**Subject** ▶ Change of Switch and Handle Complete

**For Models** ▶ 4110C

**Description** ▶ In order to conform to the European Standards;  
 1) Switch without Lock button has been replaced by the one with Lock-off button.  
 2) Handle has been changed to accept the new switch.

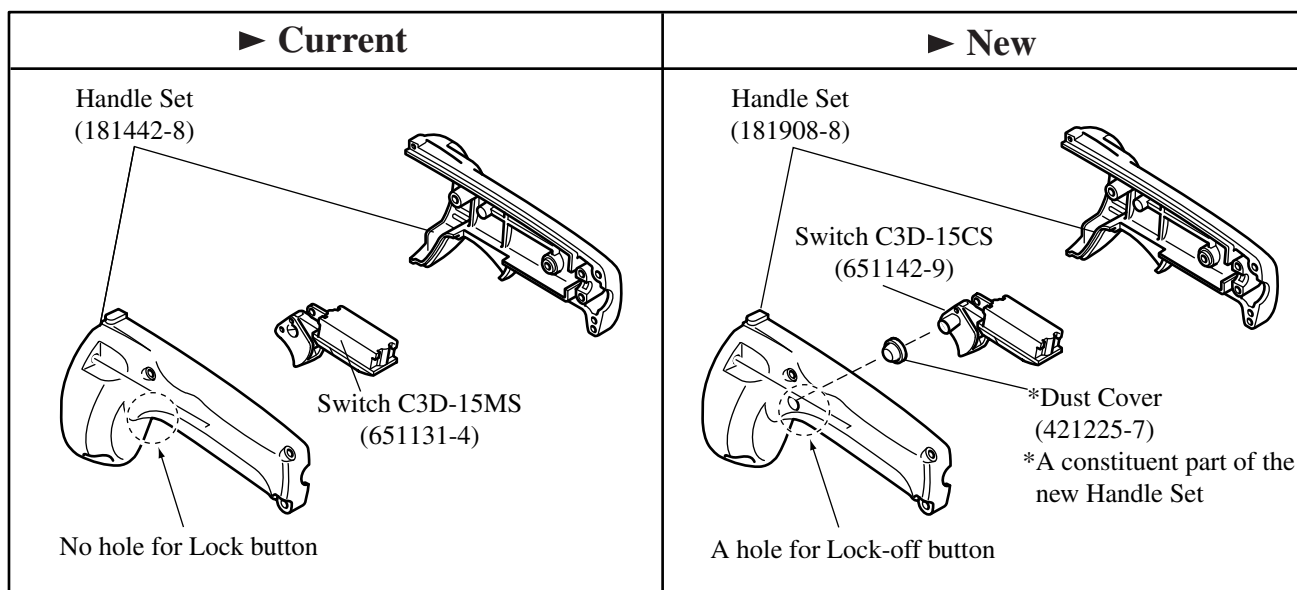
The wiring remains unchanged.

Item No.	Current part		Q'ty	I/C	New part		Q'ty	Note
071	Switch C3D-15MS 651131-4		1	No	Switch C3D-15CS 651142-9		1	Interchangeable as a set
066, 077	Handle Set 181442-8		1	No	Handle Set 181908-8		1
